# SERVICE BULLETIN REVISION NOTICE

NACELLE - EXHAUST - LUG, THRUST REVERSER LOWER OUTBOARD TRACK ASSEMBLY  
LANYARD ATTACH – MODIFICATION OF

Turbojet Engine Service Bulletin No. V2500-NAC-78-0097 Revision No. 1 dated May 9, 2017

NACELLE - EXHAUST - LUG, THRUST REVERSER LOWER OUTBOARD TRACK ASSEMBLY  
LANYARD ATTACH -MODIFICATION OF

OUTBOARD TRACK ASSEMBLY LANYARD ATTACH LUG  
FIGURE 1

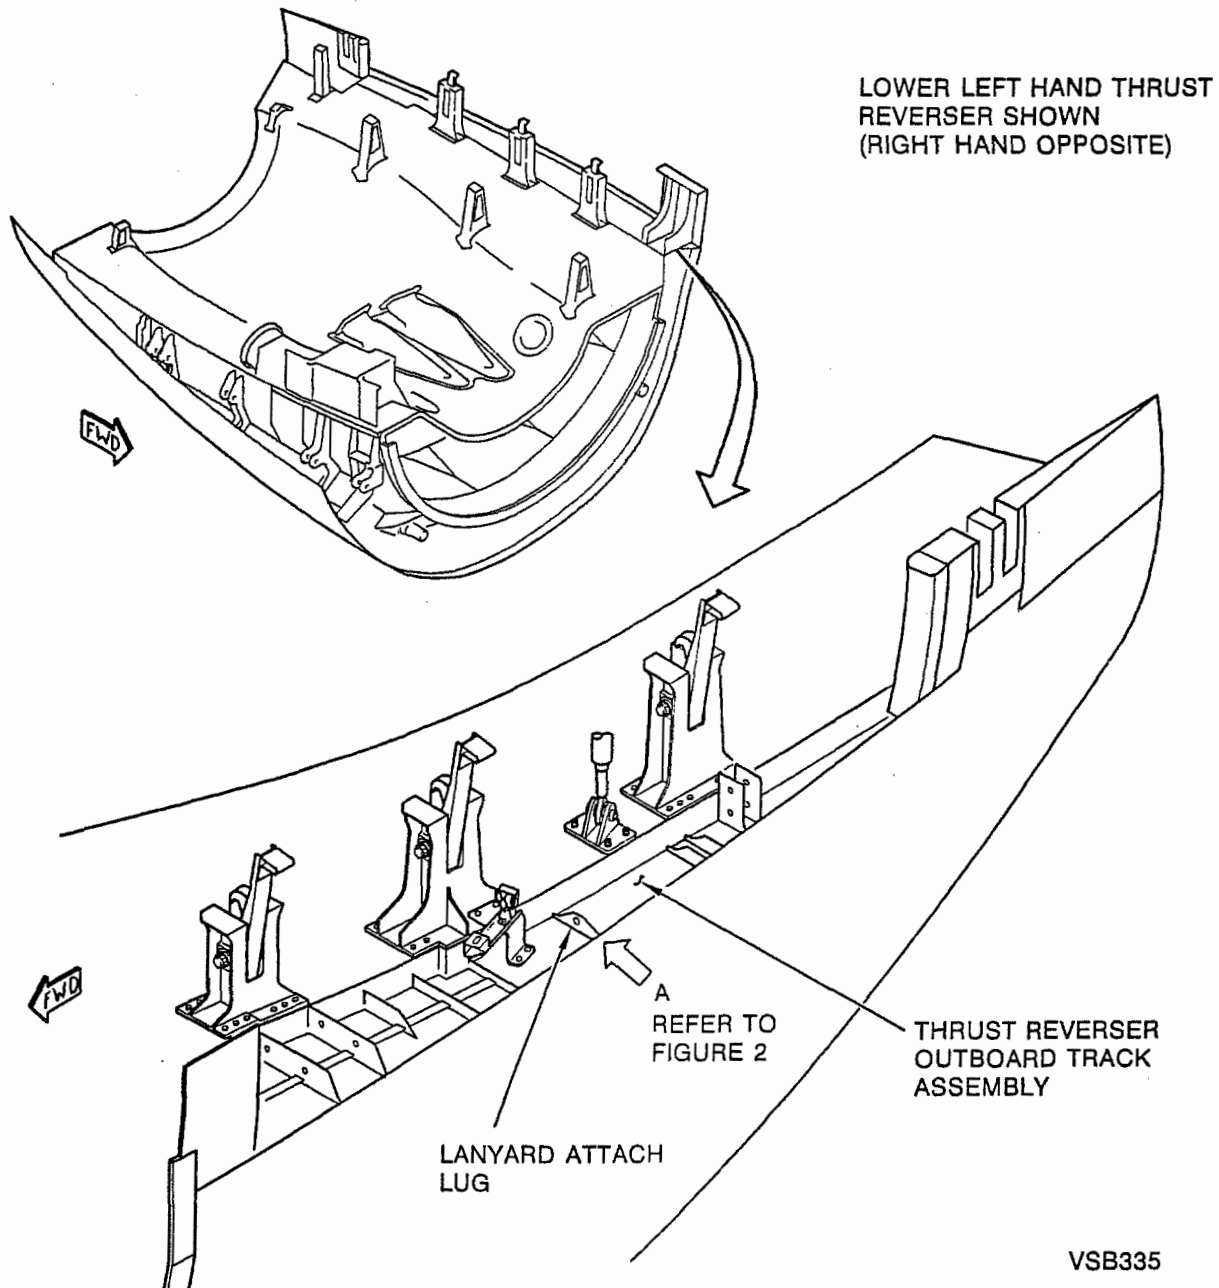
- (1) Carefully pull back insulation blanket on outboard track assembly of left hand lower thrust reverser to get access to rework area. Refer to Figure 1.
- (2) If installed, remove S700B0116-5C8 or S700B0116-5C16 bushing. Refer to Figure 2. Discard bushing.
- (3) If installed, remove 94-B043600-M angle bracket. Discard bracket.
- (4) Remove material from track assembly as shown in Figure 2.
- (5) Clean away metal chips or other unwanted material with dry air supply.

LANYARD FITTING HOLE LOCATIONS  
FIGURE 3

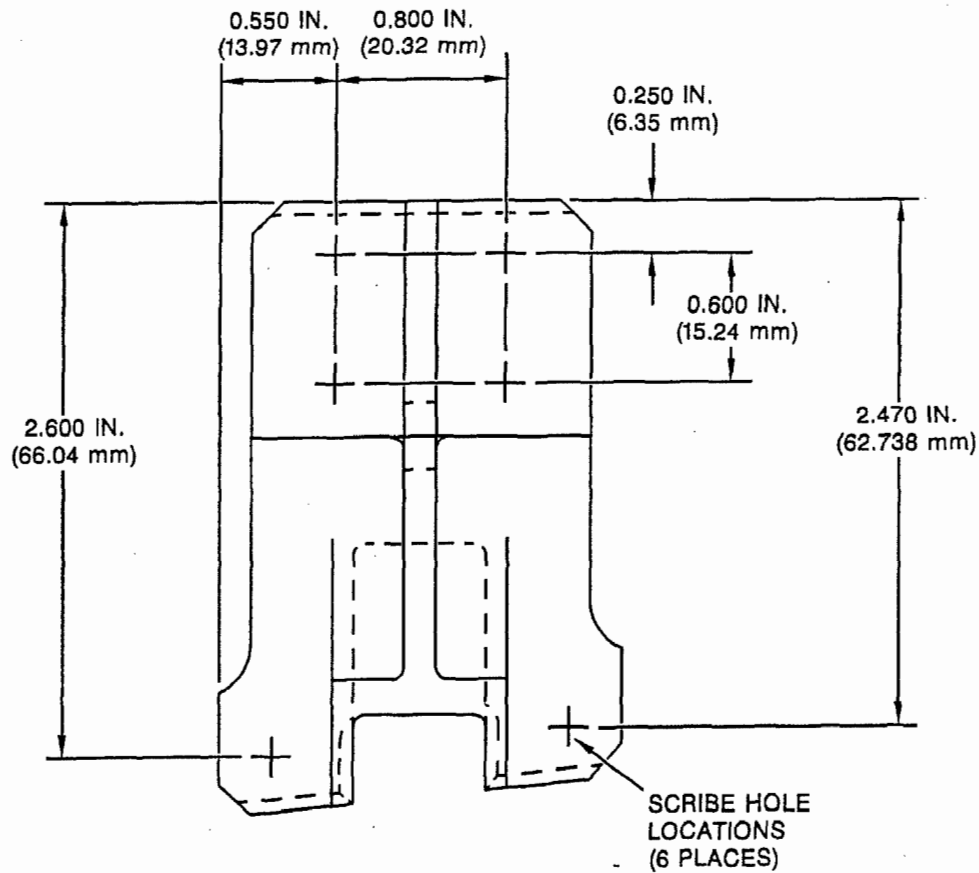
- (12) Make a mark for hole locations on 290M0003-1. Refer to Figure 3.
- (13) Attach with a clamp 290M0003-1 fitting and two 290M0003-3 radius blocks to lower track assembly. Refer to Figure 4.
- (14) Drill fastener holes through fittings, lower track assemblies, and radius blocks.
